Re: **Docket No. 521 – Application of Tarpon Towers III, LLC and Cellco Partnership d/b/a Verizon Wireless for a Certificate of Environmental Compatibility and Public Need for the Construction, Maintenance and Operation of a Wireless Telecommunications Facility at 1021-1041 South Main Street in Cheshire, Connecticut**

RESPONSES OF CELLCO PARTNERSHIP D/B/A VERIZON WIRELESS TO
CONNECTICUT SITING COUNCIL INTERROGATORIES (SET ONE)

ATTACHMENT 1

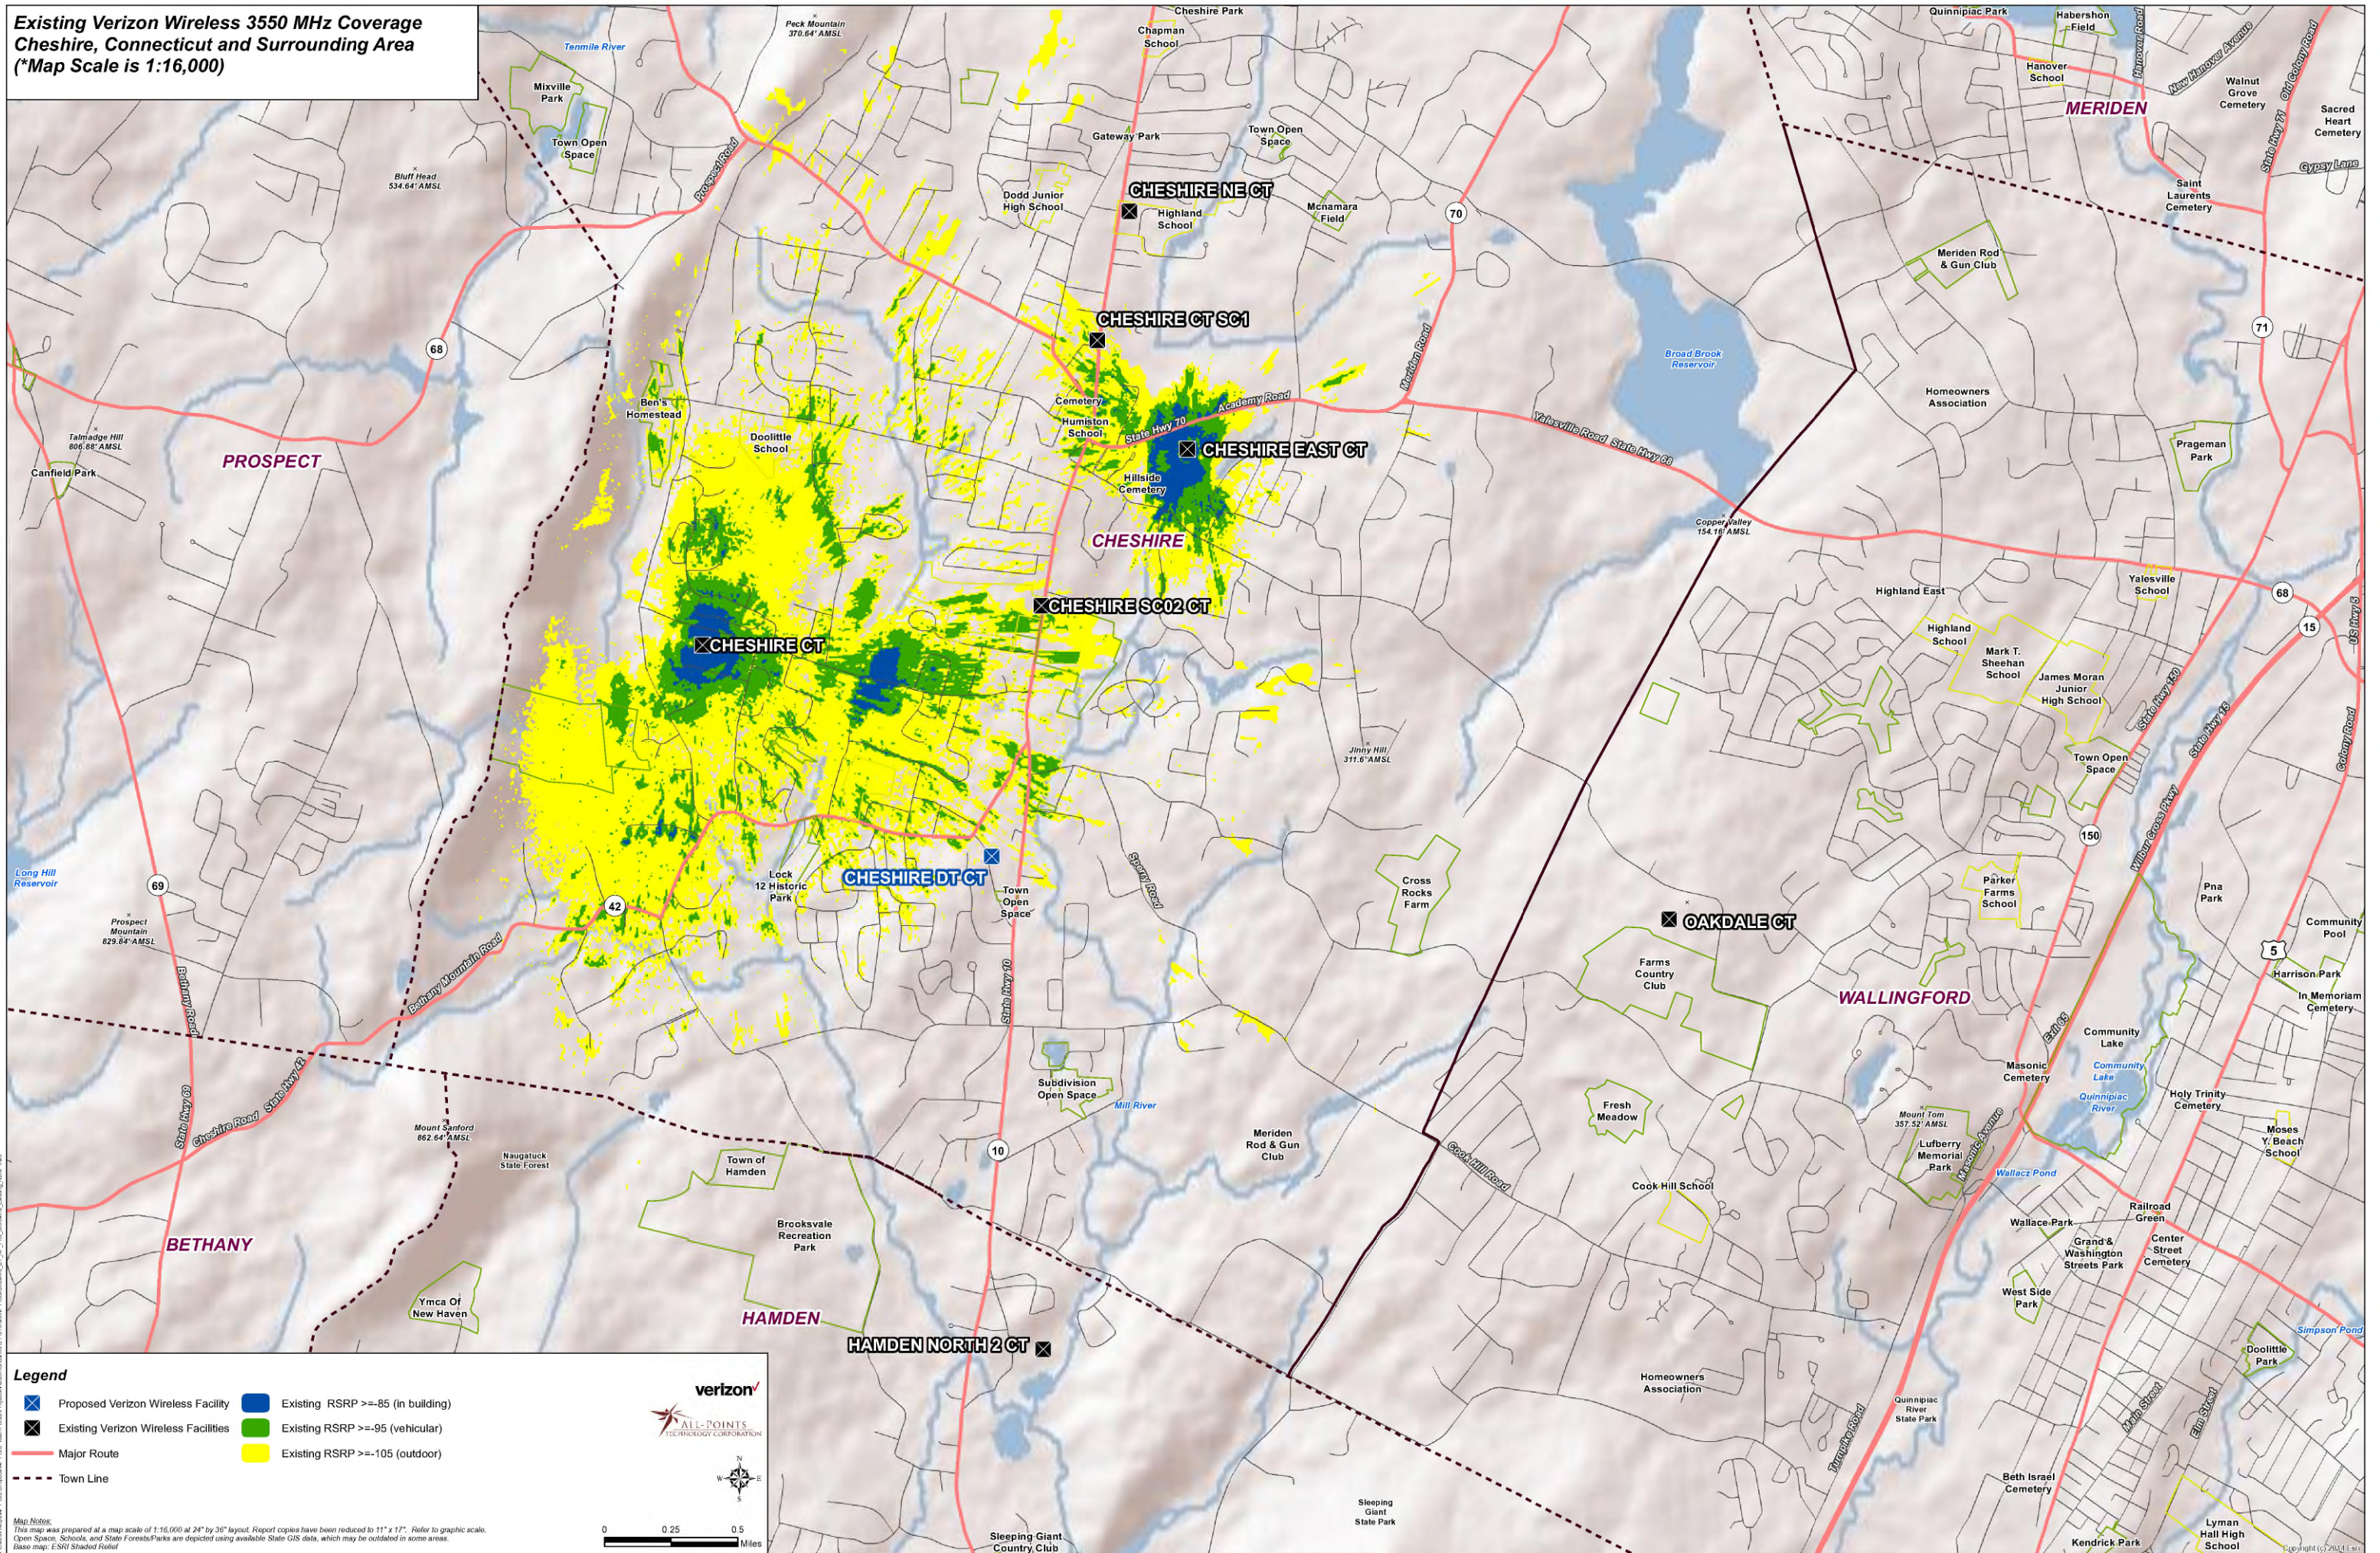
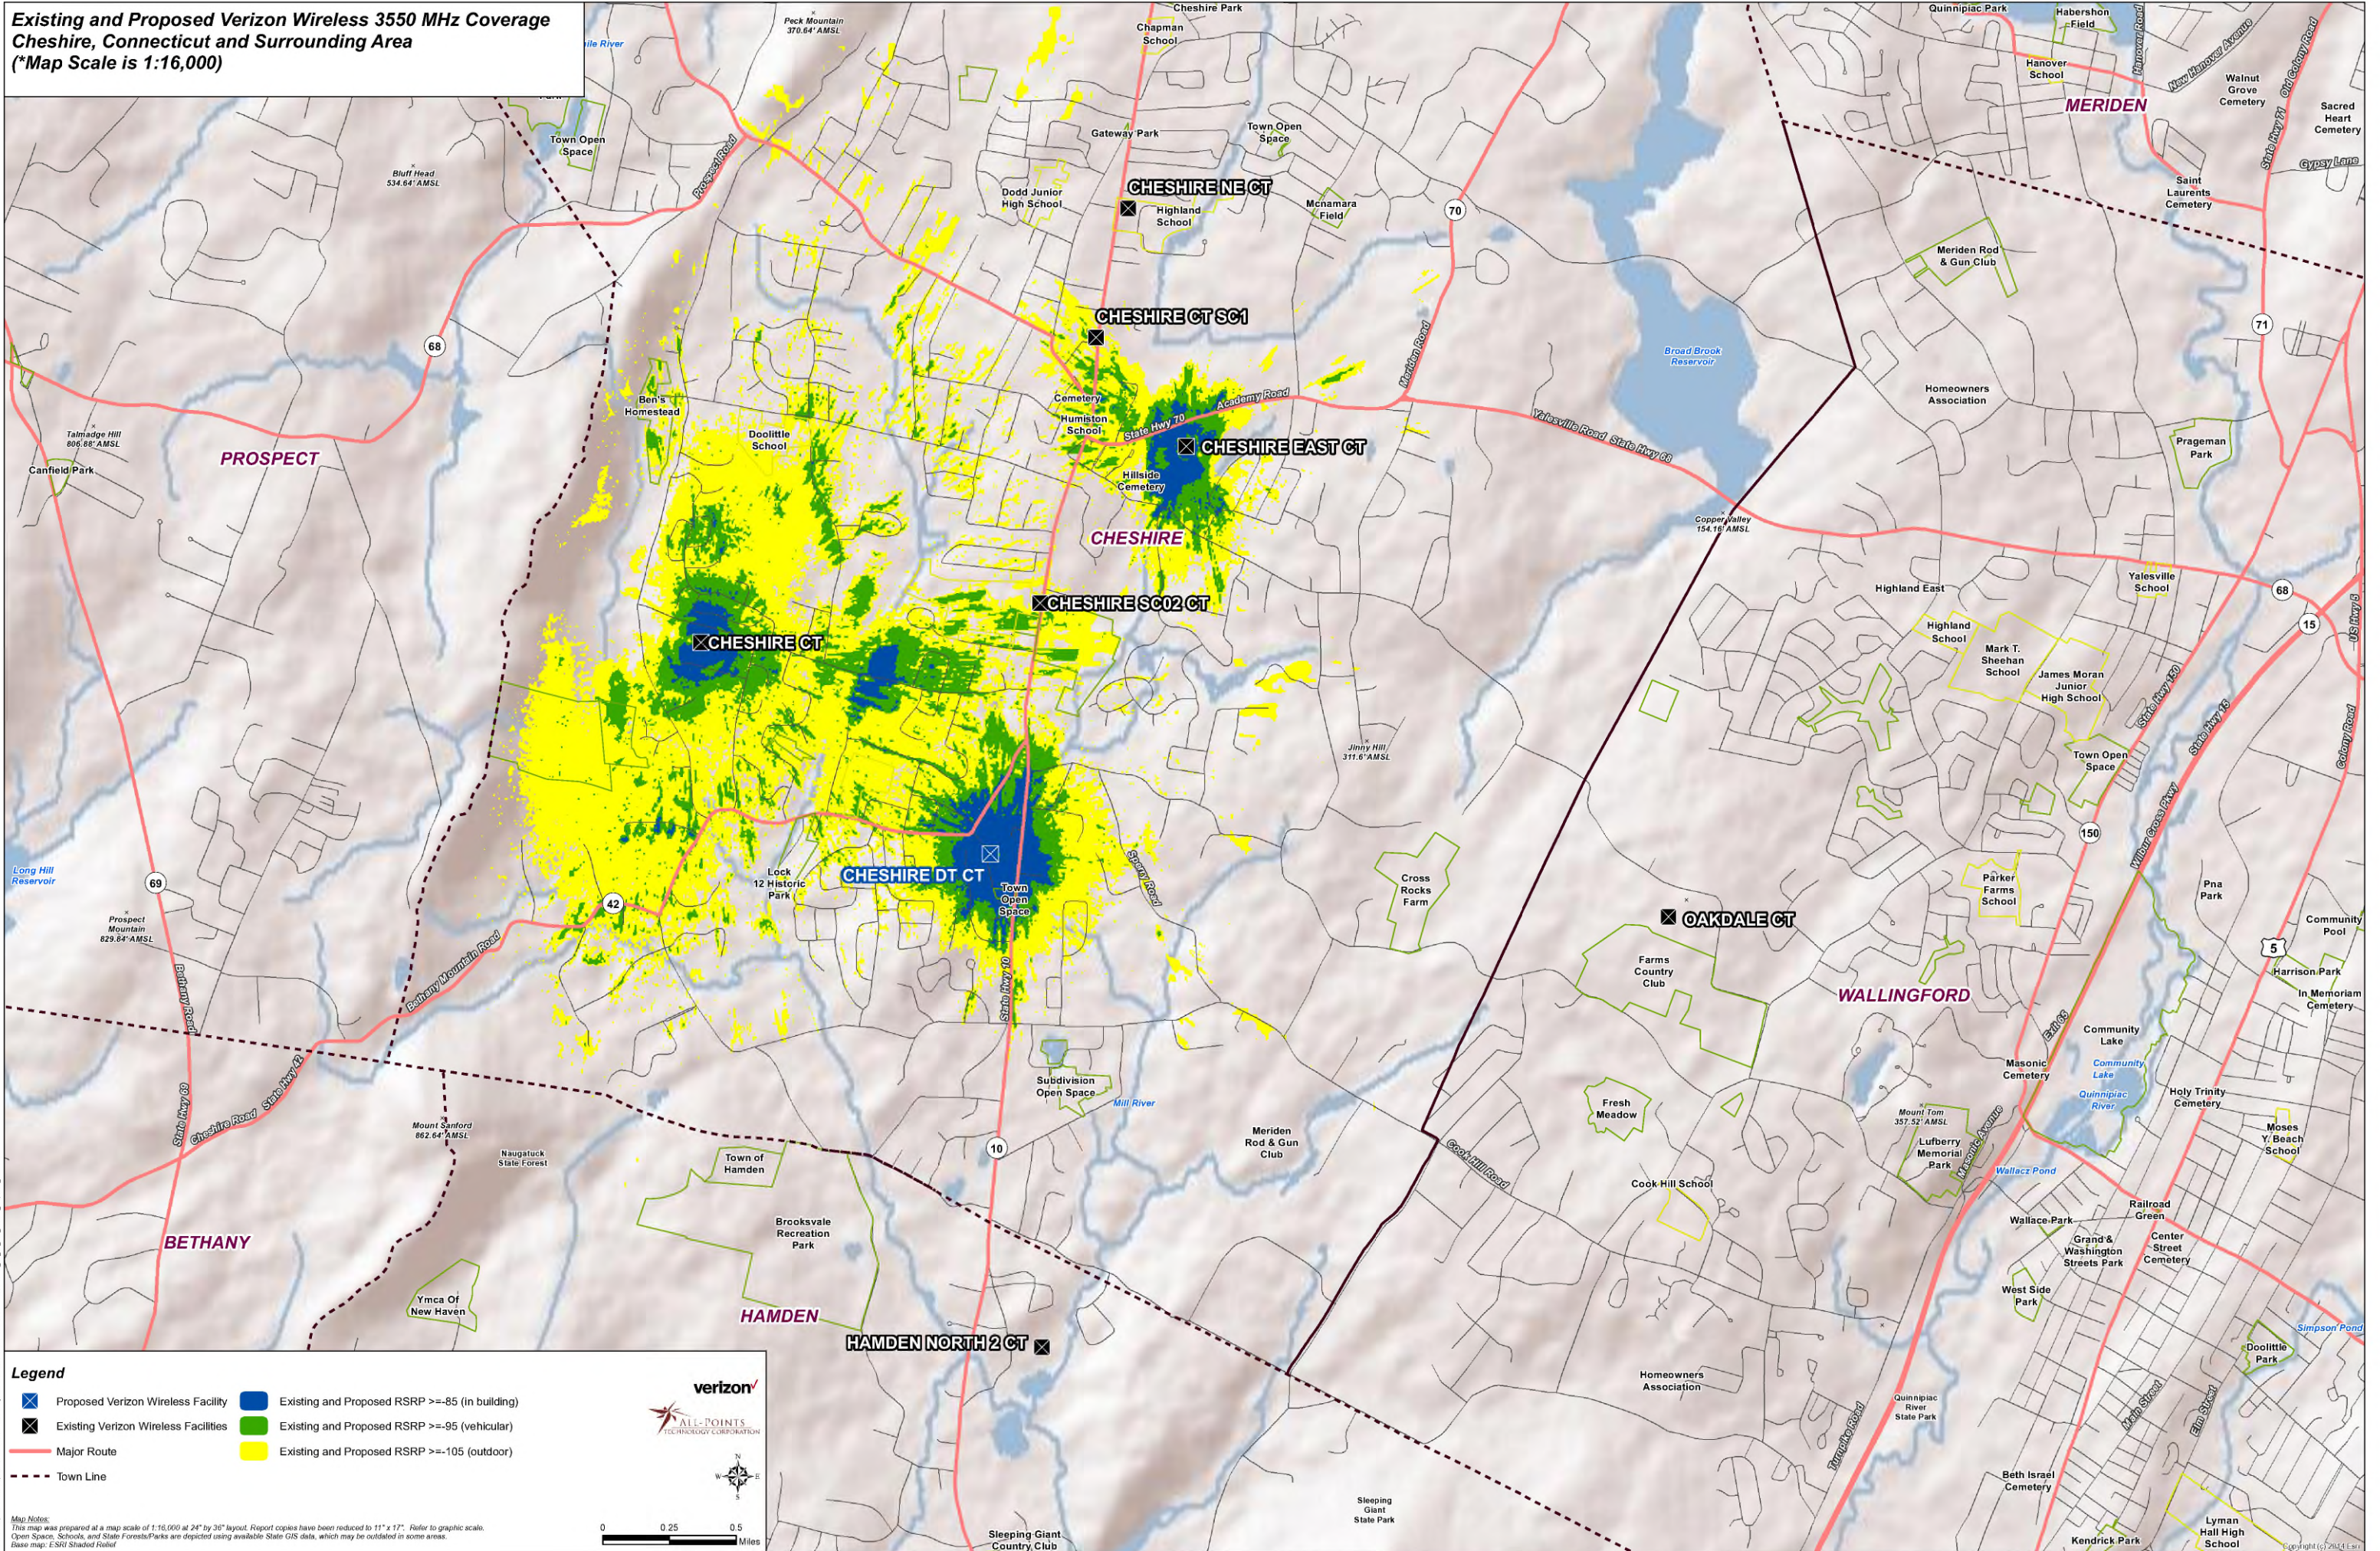
Are all frequencies used to transmit voice and data?

All of Cellco’s licensed frequencies (700 MHz, 850 MHz, 1900 MHz, 2100 MHz, 3550 MHz, 5G) are used, however, to transmit both voice and data services. Included in Attachment 1 are “Existing” and “Existing and Proposed” coverage plots for Cellco’s 3500 MHz and 5G frequencies, which were not included in the Application.
